South Bay Bus Rapid Transit (BRT)

Addendum to the Final EIR

*State Clearinghouse No. 2010041060
Final EIR Certified July 26, 2013*

October 2014

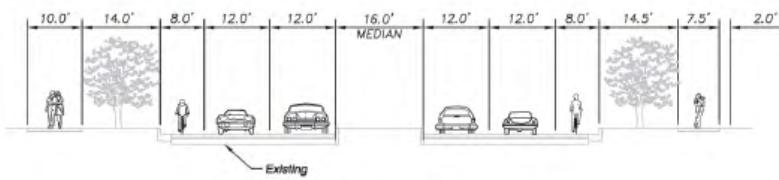
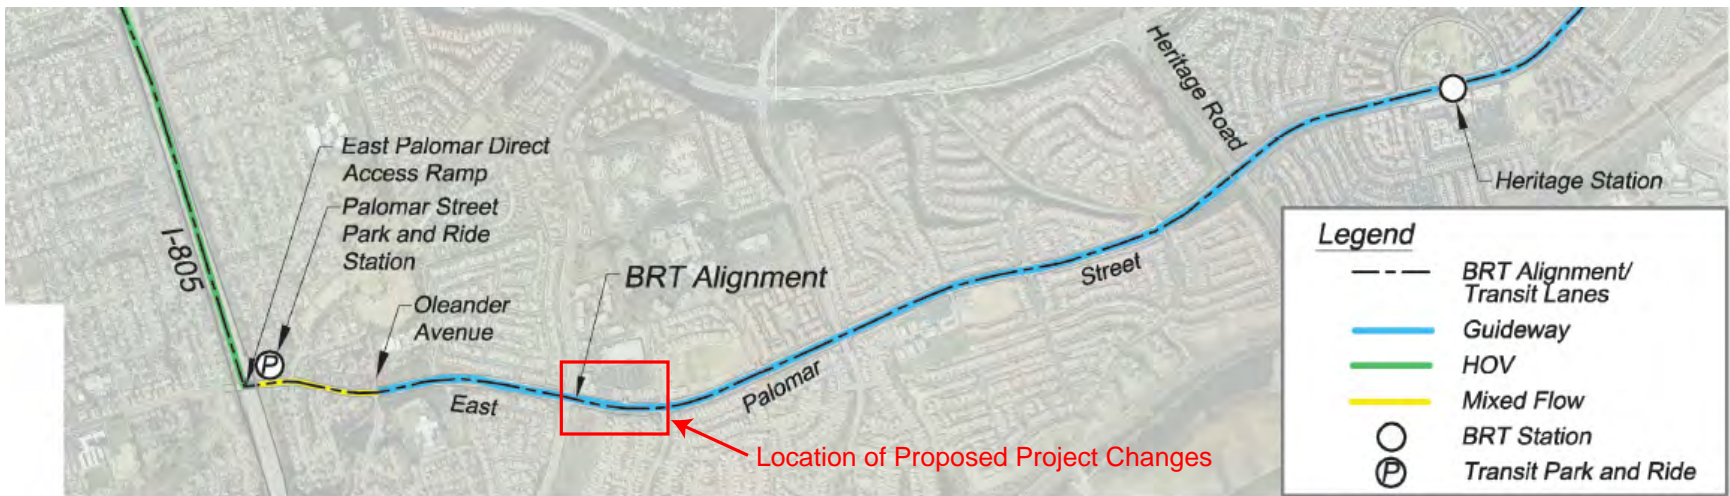
Under the proposed changes, a traffic signal would still be installed at the intersection of East Palomar Street and the Commercial Driveway, same as the approved Project. However, the outbound left-turn lane from the Sunbow Shopping Center's mid-block driveway onto eastbound East Palomar Street would be replaced with a second right turn lane onto westbound East Palomar Street (Figure 1-3). All other turning movements would remain the same as the approved Project (i.e., left in, right in, right out). SANDAG, in consultation with the City of Chula Vista, proposes to make the change because maintaining the left-out turn lane would:

Increase delay and decrease operational performance of the buses operating in the guideway because an additional signal phase would be required for the left-out turn.

- Encourage pedestrians to cross East Palomar Street at this intersection since eastbound through traffic would be required to stop during the signal phase for the left turn out. Adding a pedestrian crossing phase to the traffic signal would increase delay and decrease bus operational performance through this intersection.
- Be subordinate to all other movements entering that intersection. Overall travel times using other driveways (discussed below) would not be meaningfully different.

Plan View and Typical Section for East Palomar Street Guideway between Heritage Road and Oleander Avenue

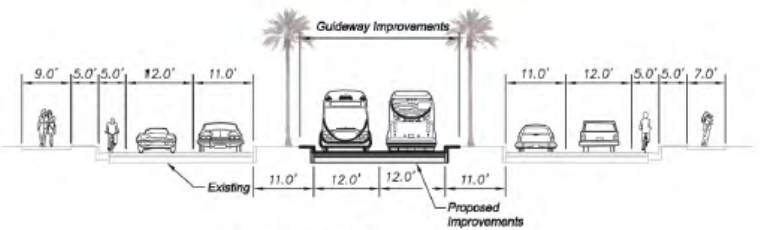
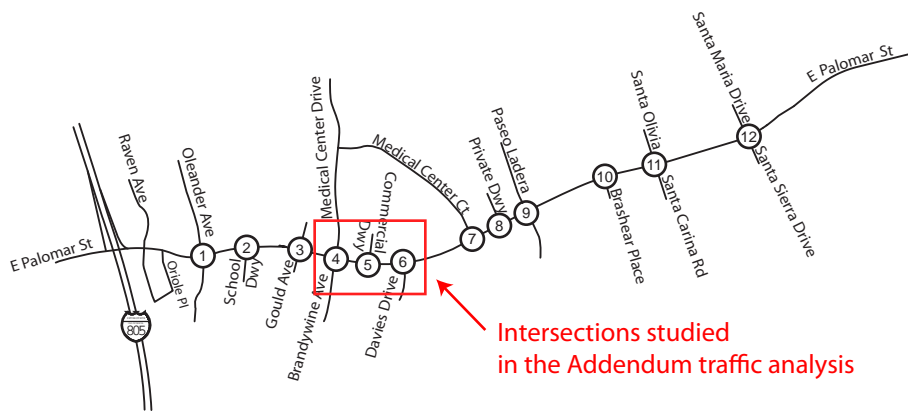
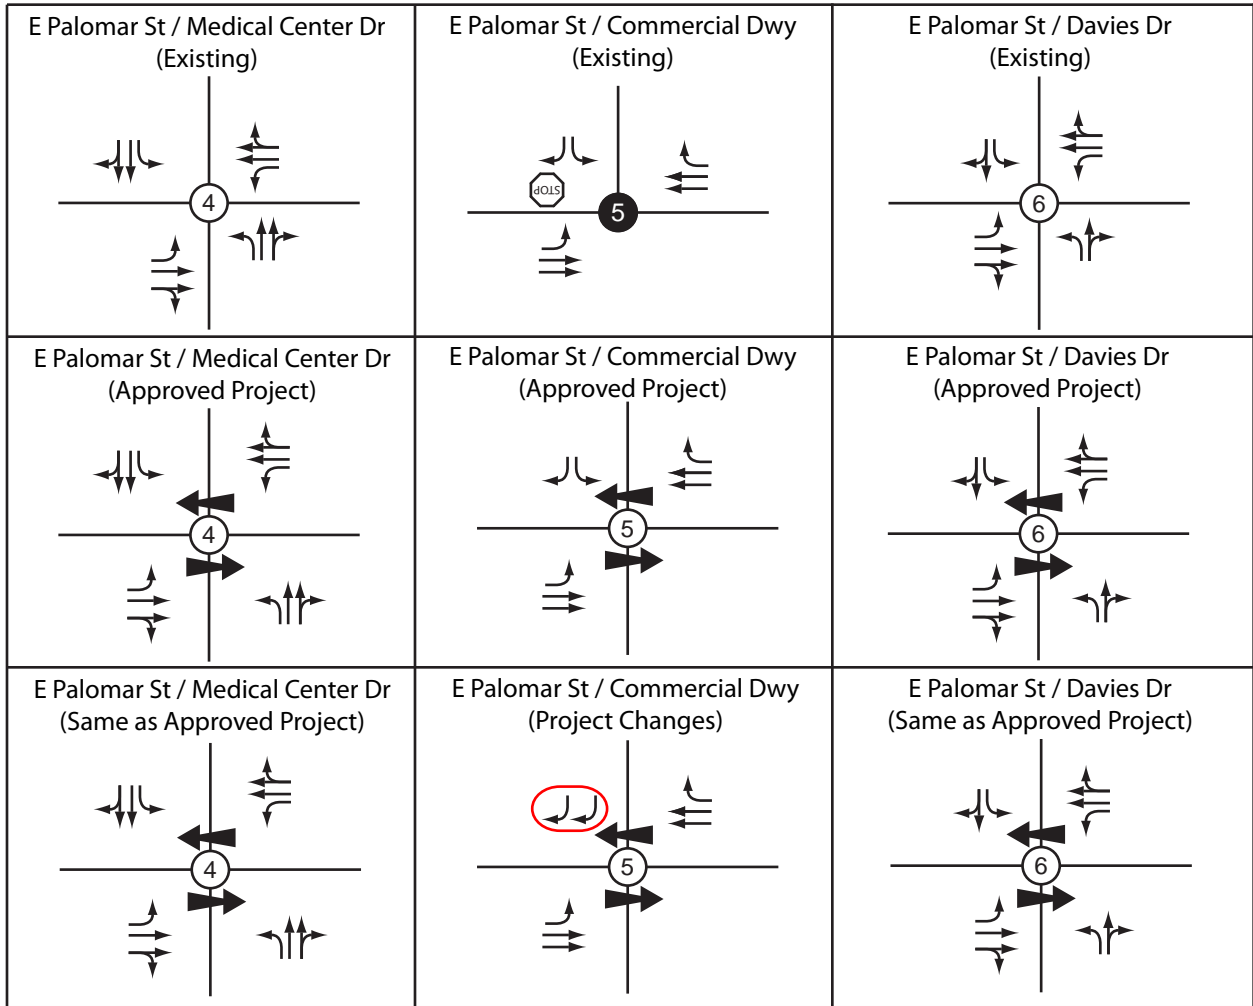
The other proposed change requires the acquisition of approximately 1,600 square feet of private property to accommodate the relocation of an existing AT&T fiber optic utility box. The property is adjacent to the East Palomar Street right-of-way at the Sunbow Shopping Center, just east of Medical Center Drive/Brandywine Avenue. The existing fiber optic utility facility would be relocated to the north side of East Palomar Street, just east of its intersection with Medical Center Drive (sidewalk relocation was included in the approved Project and considered in the Final EIR). The sidewalk would be redirected to the north of the fiber optic utility box, which would cut into the sloped landscaping strip between the sidewalk and commercial shopping center parking lot, requiring the construction of a concrete masonry retaining wall with graffiti coating varying in exposed height from one to seven feet and approximately 80 feet long. Retaining wall construction would involve approximately 125 cubic yards of cut and approximately 10 cubic yards of fill. Ornamental landscaping will be installed between the retaining wall and the sidewalk.
